FIG. 31

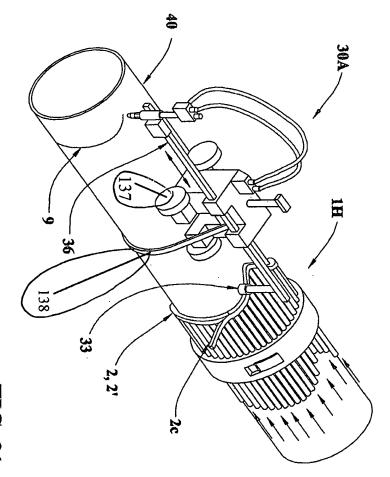
The examiner objected to claims 22 and 31 for failing to provide a proper antecedent basis for "a chain and wheels" in the specification.

Figure 31 shows the chain and wheels described in claims 22 and 31. Page 19 of the specification has been amended to add the wheels and chain to the specification. Figure 31 has been amended to add reference numbers for the wheel and the chain. A replacement page for Fig 31 is attached with the corrections shown in red.
